EDMS NO. 1973028	REV. 0.1	VALIDITY DRAFT
----------------------------	--------------------	--------------------------

REFERENCE LHC-TC-EC-0013

ENGINEERING CHANGE REQUEST

Installation in IR7 of Dispersion Suppressor Collimators (TCLD)

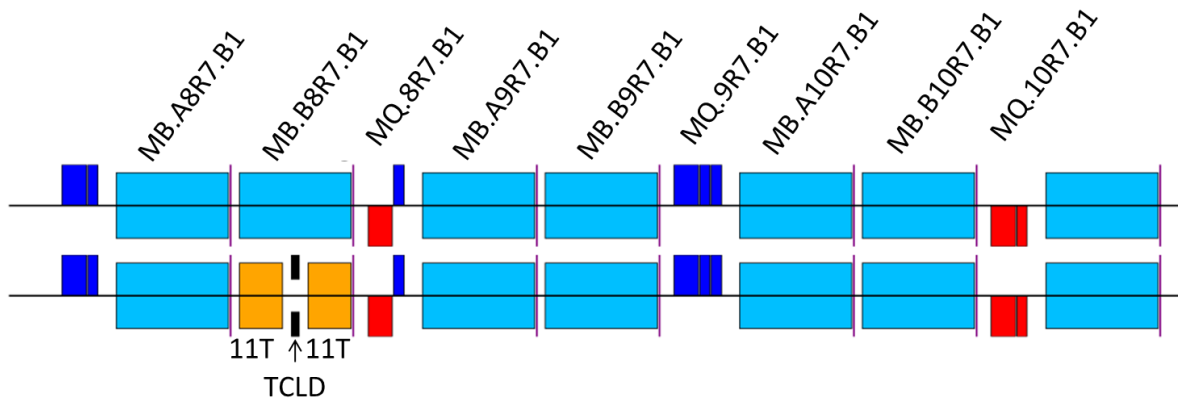
Simulations and present knowledge of the quench limits of the standard dipoles as well as the 11 T magnets have shown that the preferred placement of the TCLD is in cell 8 (on the right side of IR7 for B1 and left side for B2) [8]. The standard dipoles to be replaced by the assembly of two 11T magnets are MB.B8R7 and MB.B8L7. The schematic layouts of the present and post-LS2 IR7 dispersion suppressor on the left side of IR7 are shown in Figure 1.

Figure 2 - Positions of new TCLD collimators in IR7. Figure taken from Ref. [12].

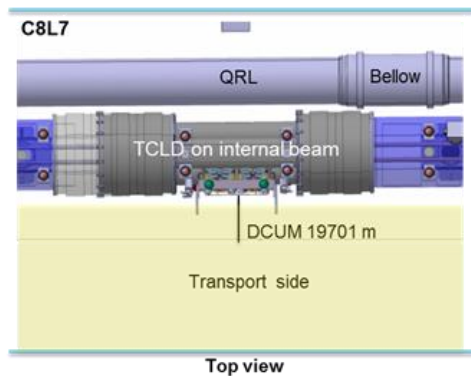
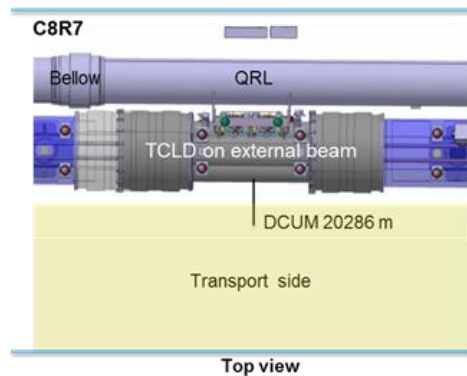
The integration and positions (DCUM) of the two TCLDs are shown in the drawings in Figure 2. More details on the integration are presented in [12], although this document (version from March 2018) needs to be updated with the very latest design additions.

TCLD distance from IP1 (DCUM): 19701,7684 m
TCLD distance from IP7: - 292,394 m
11T+TCLD area from IP7:
[- 284,564 m – - 300,224 m]

TCLD distance from IP1 (DCUM): 20286,5564 m
TCLD distance from IP7: 292,394 m
11T+TCLD area from IP7:
[284,564 m – 300,224 m]
